Sinha Knit Industries Ltd. (10184)

29.APRIL.2014

Identified Priority 3 Concerns

1st Priority 1 Concern

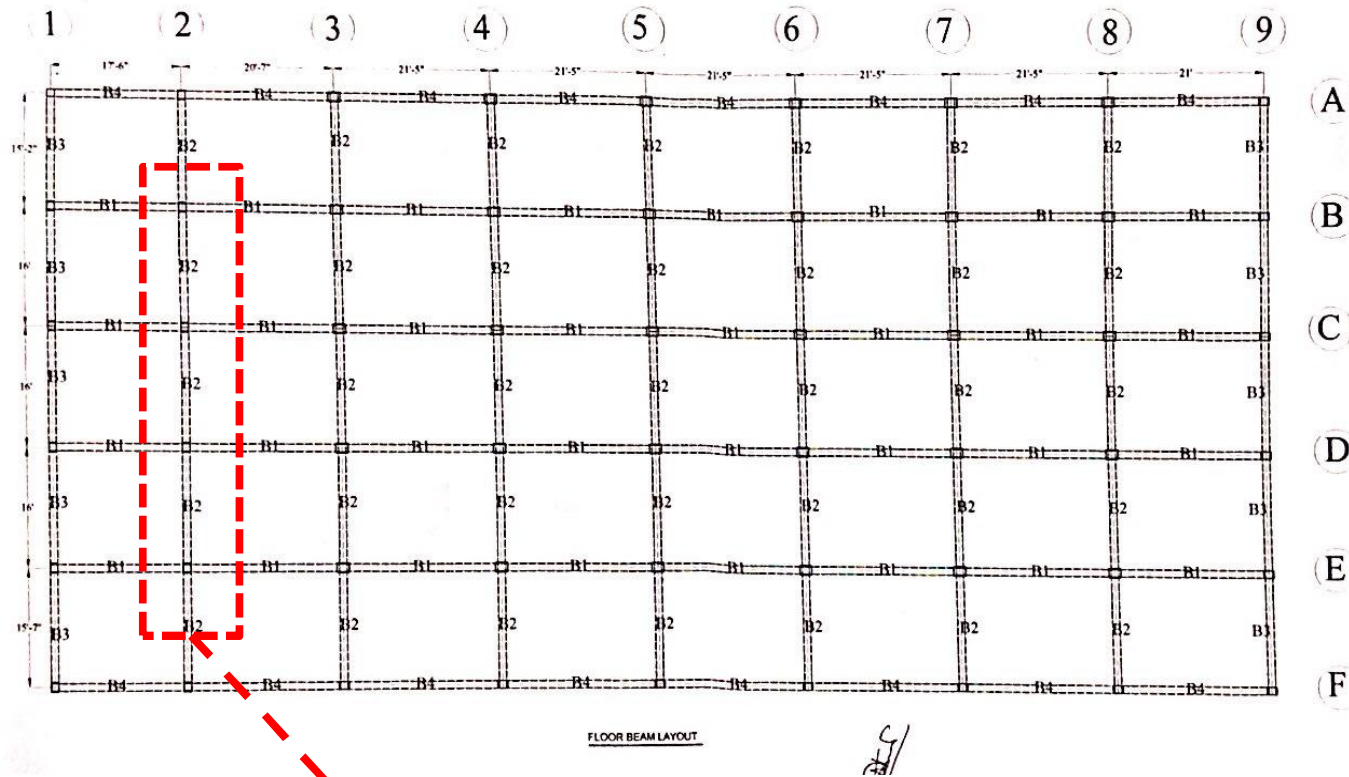
These columns (300x380 mm) on the 2nd grid line have been checked for their loading capacity.

Based on the structural design and the Ferro-scan results, the column reinforcement in some columns appears to be inconsistent with the rebar arrangement at the ground level. According to the load rundown calculation, typical columns have been found to possess marginal loading capacity, thus attaining an 'AMBER' warning.

Column possesses low factor of safety

- Carry out a full Detailed Engineering Assessment of the entire building including any intrusive testing required.
- Carry out full survey of all structural elements to check the loading capacity of the overall structural system.
- The Factory Engineer to review design, loads and columns stresses in entire building in accordance with BNBC regulations

1st Priority 3 Concern

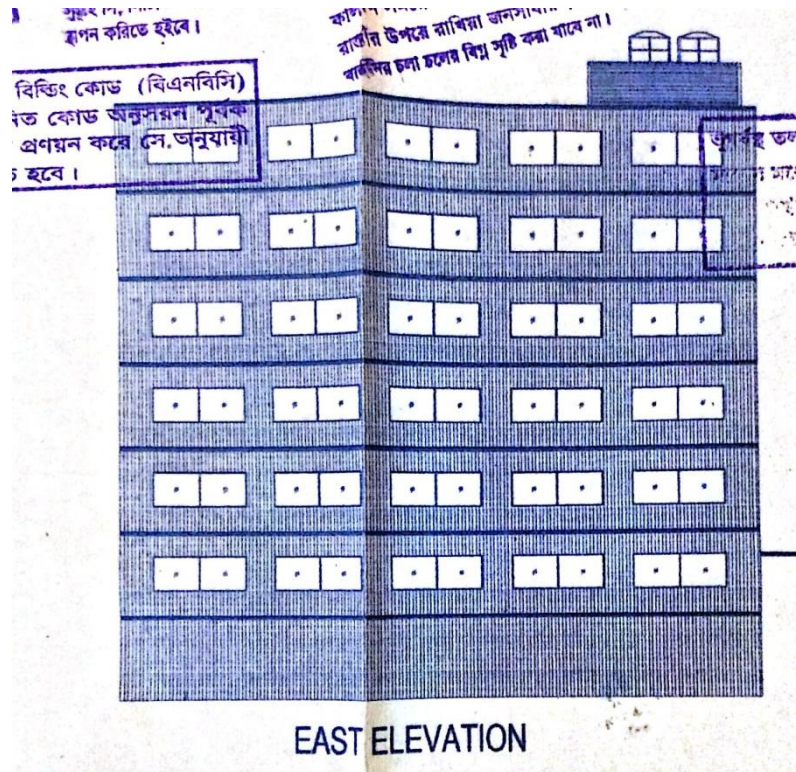
Other than the undersized C2 columns on the 2nd grid line. All other C2 columns have the correct size of 380x460 on all floors.

The columns C2 have been designed with 12 bars of 20mm diameter for all floor levels. However, the Ferro-scan image and picture of those columns on the top floor suggests 10 bars only. Lack of 2 bars leads to a lower factor of safety for those columns.

The structural record is not reliable

- Based on the building survey, building engineer to develop full structural records and check for compliance with BNBC codes.
